Doc. No.: T13/E01028R0
Date: 12/3/2001
Project: 1410D
Ref. Doc.: E01025R0
D1410R3
Reply to: Peter McLean

Subject: Results of letter ballot E01025R0

Comments accompanying Maxtor Yes vote on letter ballot to forward ATA/ATAPI-6.

Figure 29 - Host DMA state diagram

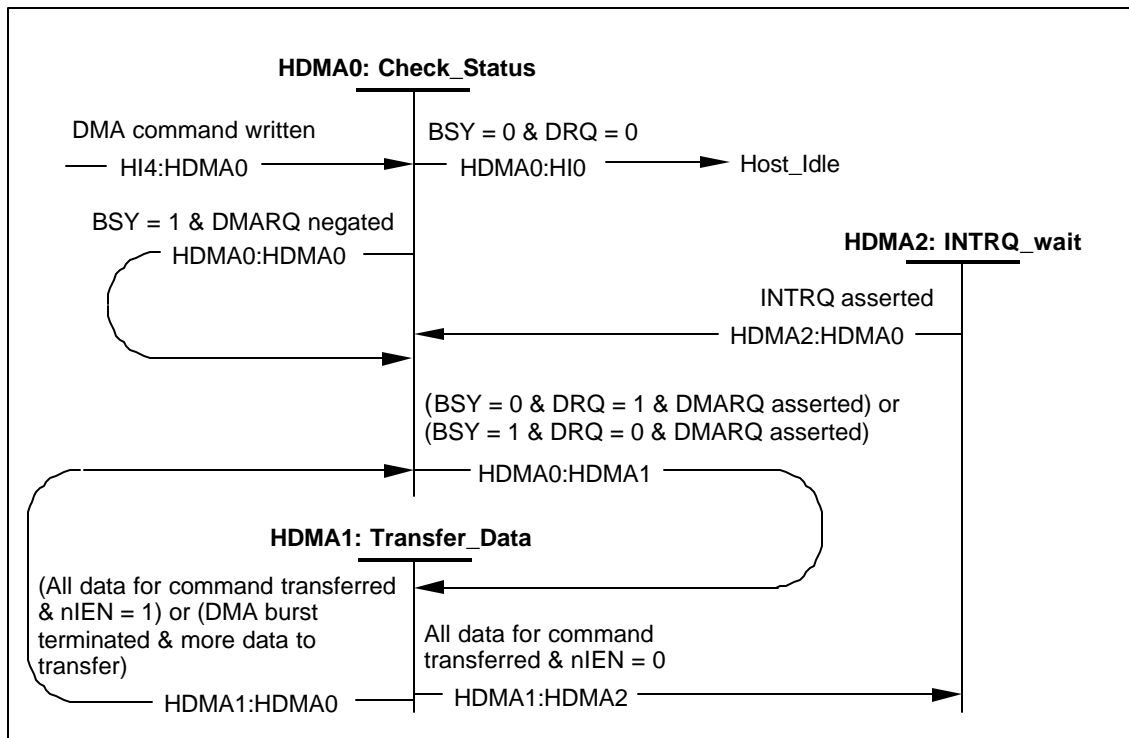
There is confusion as to whether or not all data must be transferred in a single DMARQ/DMACK assertion. To alleviate the confusion, it is proposed that figure 29, the text for the HDMA1 to HDMA0 transition, figure 30, and the text for the DDMA1 to DDMA0 transition be modified as shown.

Transition HDMA1:HDMA0: When the host has transferred all data for the command and nIEN is set to one or when the DMA burst has been terminated and all data for the command has not been transferred, then the host shall make a transition to the HDMA0: Check_Status state.

Figure 33 - Host PACKET DMA command state diagram

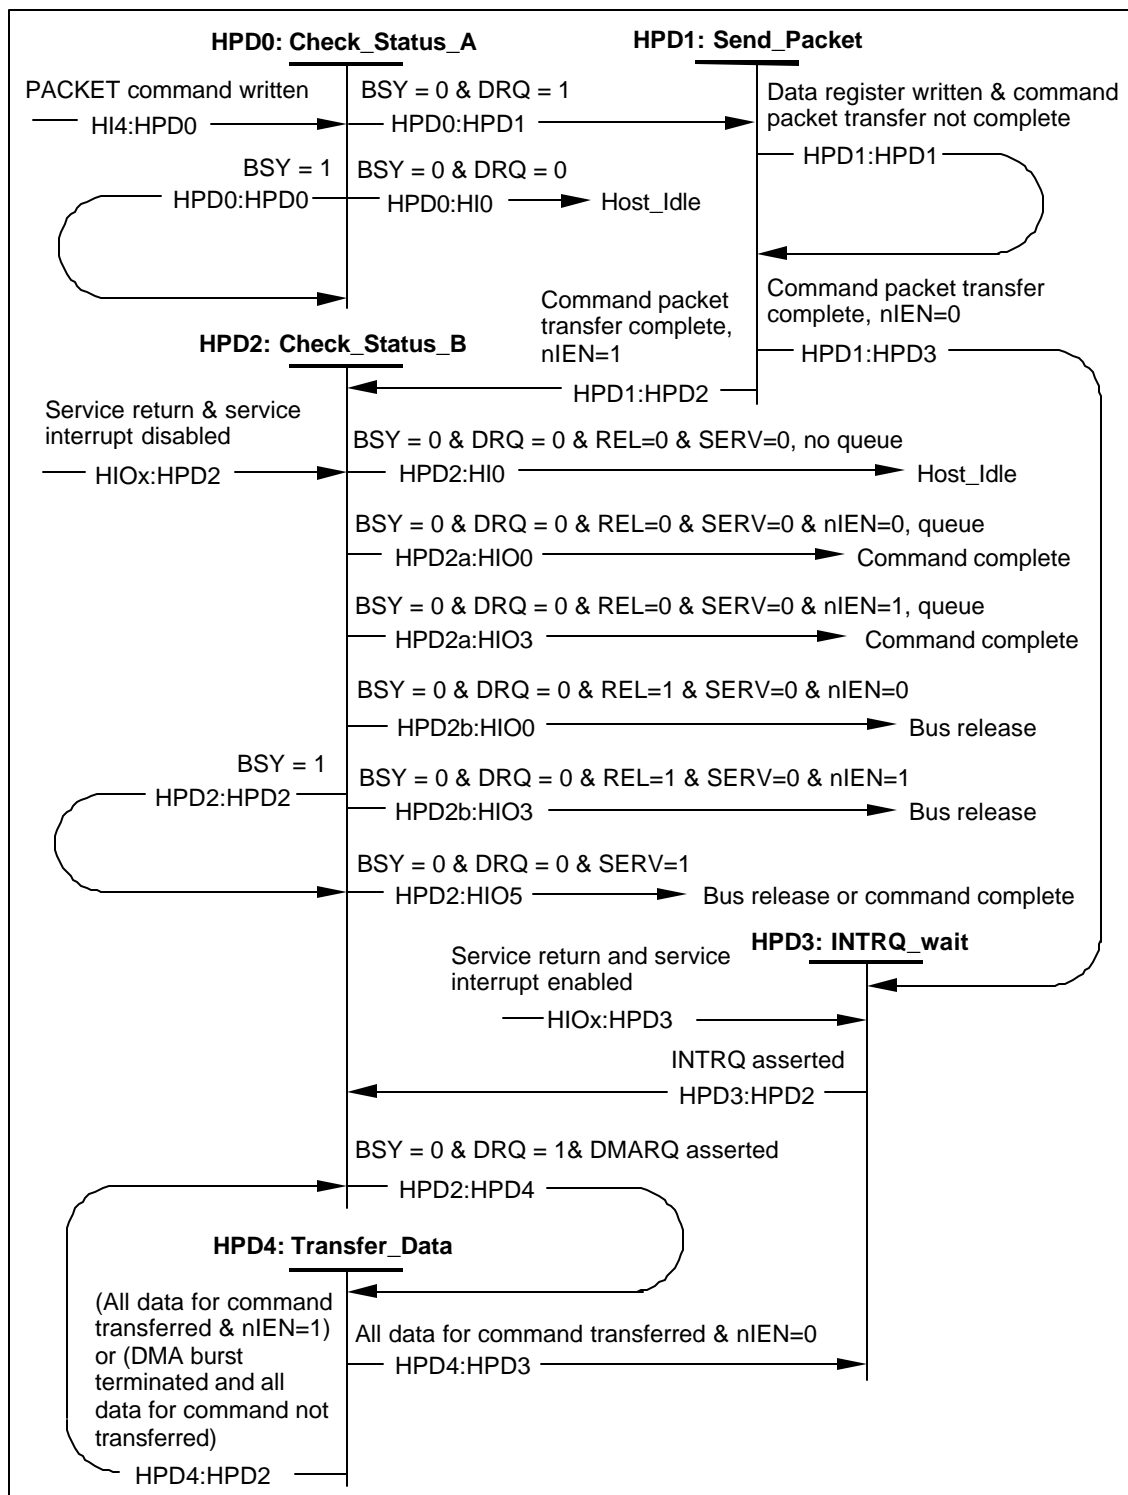
There is confusion as to whether or not all DMA data must be transferred in a single DMARQ/DMACK assertion. To alleviate the confusion, it is proposed that figure 33, the HPD4 to HPD2 transition, figure 34, and the text for the DPD4 to DPD2 transition be modified as shown.

Transition HPD4:HPD2: When the host has transferred all data for the command and nIEN is set to one or when the DMA burst has been terminated and all data for the command has not been transferred, then the host shall make a transition to the HPD2: Check_Status_B state.

Figure 35 - Host DMA QUEUED state diagram

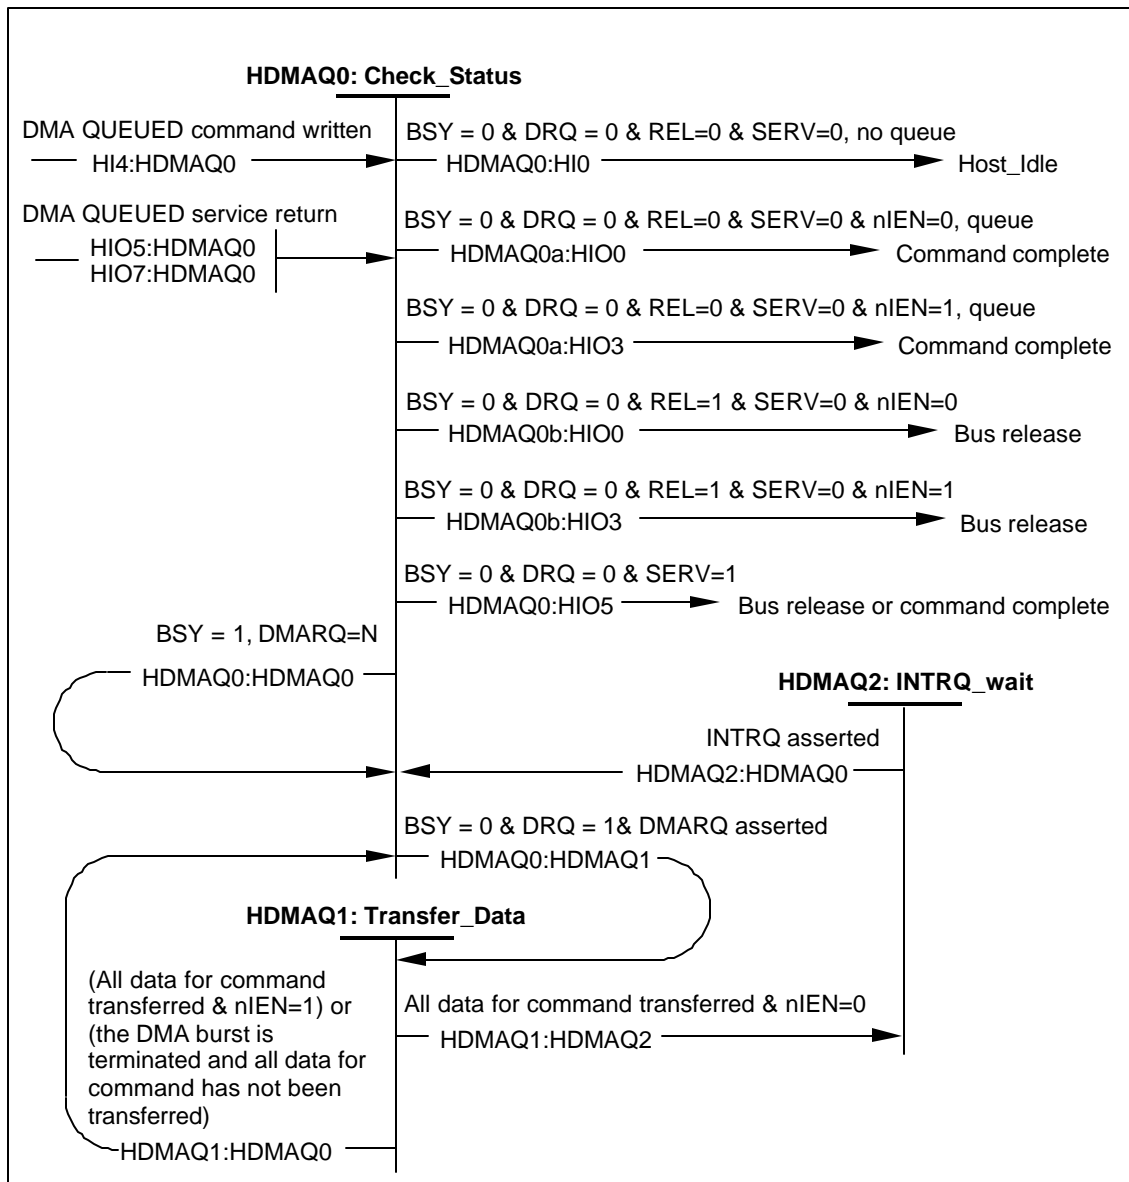
There is confusion as to whether or not all DMA data must be transferred in a single DMARQ/DMACK assertion. To alleviate the confusion, it is proposed that figure 35, the HDMAQ1 to HDMAQ0 transition, figure 36, and the text for the DDMAQ1 to DDMAQ0 transition be modified as shown.

Transition HDMAQ1:HDMAQ0: When all data for the request has been transferred and nIEN is set to one or when the DMA burst is terminated and all data for the request has not been transferred, then the host shall make a transition to the HDMAQ0: Check_Status state.
